**SUNDRY NOTICES AND REPORTS ON WELLS**  
*Do not use this form for proposals to drill or to re-enter an abandoned well. Use form 3160-3 (APD) for such proposals.*

**Hahn Federal 5  
30-005-20532  
Cross Border Resources, Inc.  
April 3, 2018  
Conditions of Approval**

**Permanent Abandonment of Federal Wells  
Conditions of Approval**

# BEFORE

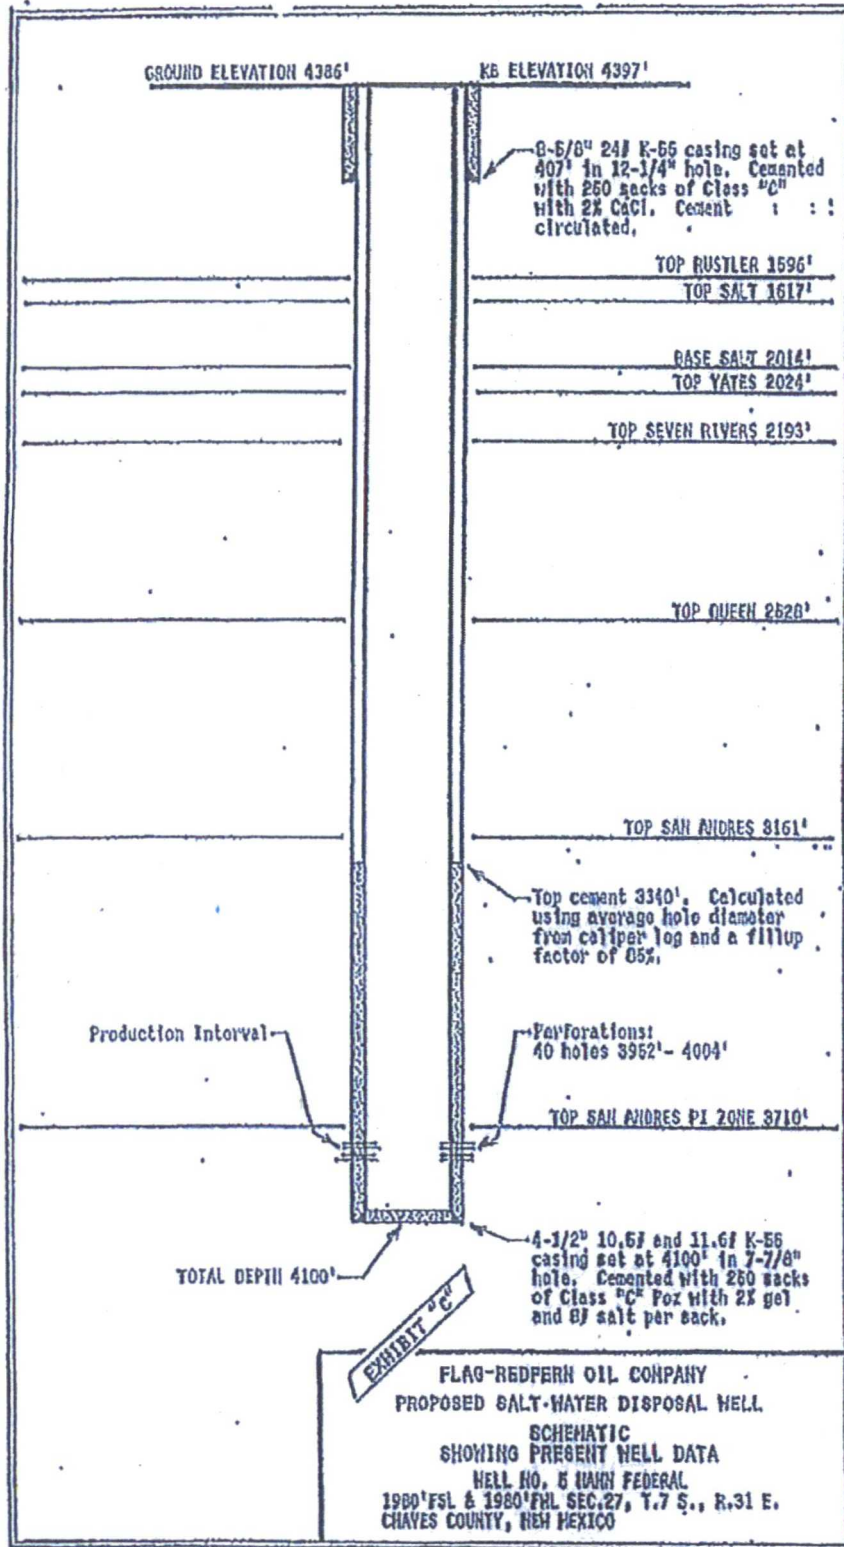
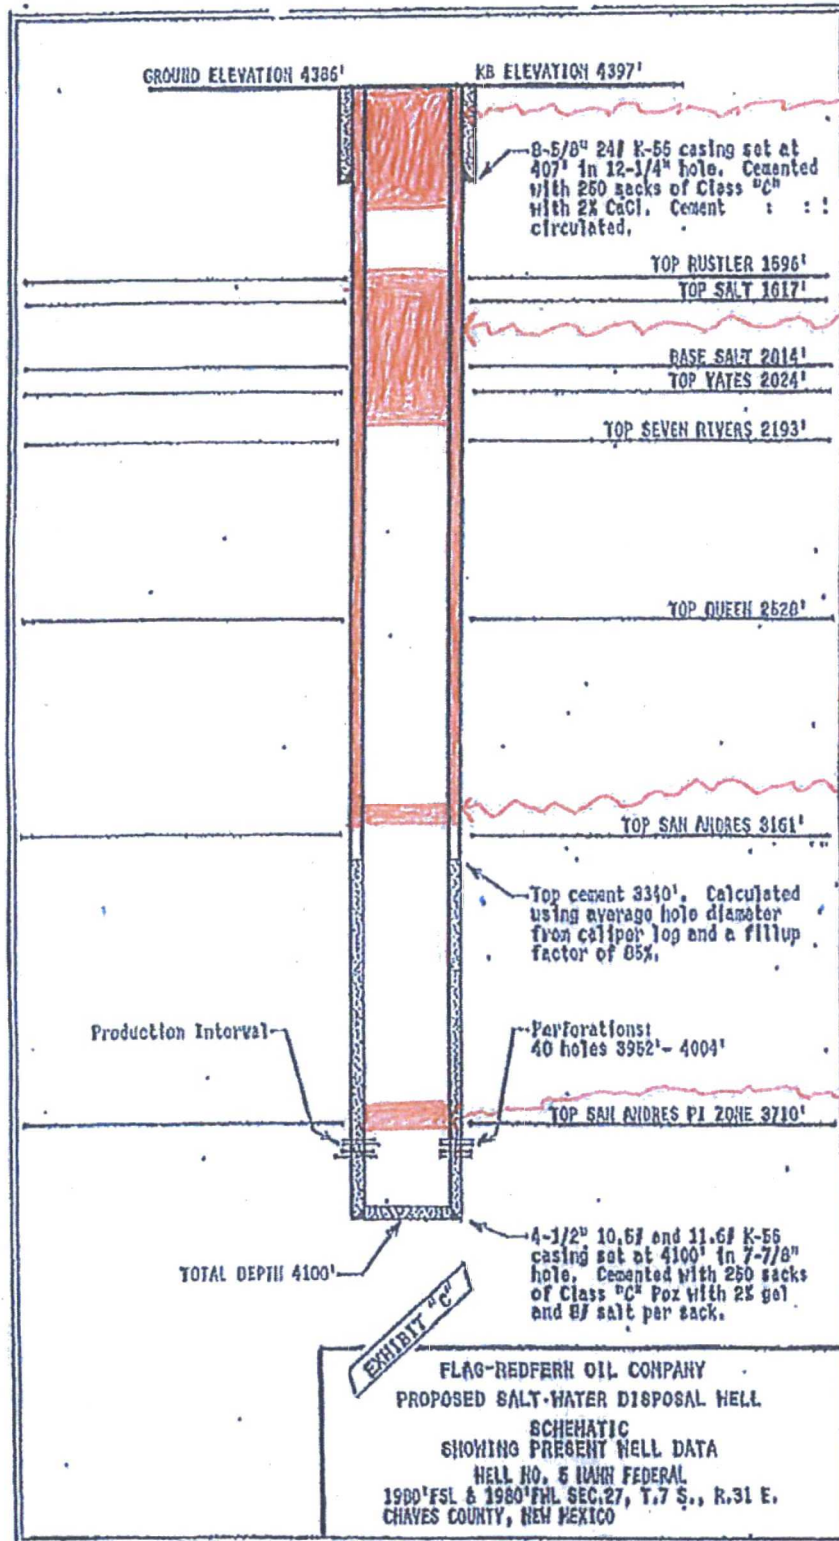
- 1. Operator shall place CIBP 50'-100' above top most perf and place 25 sx of Class C cement on top as proposed. WOC and TAG.**
- 2. Operator approved to perf and pump cement on the backside of casing as proposed. Operator shall provide method of verification. If circulation is not achieved to surface operator will need to contact BLM prior to continuing.**
- 3. Operator shall place a Class C cement plug from 2,150'-1,550' to seal the Yates Formation. WOC and TAG as proposed.**
- 4. Operator shall place a Class C cement plug form 460' to surface as proposed.**
- 5. See Attached for general plugging stipulations.**
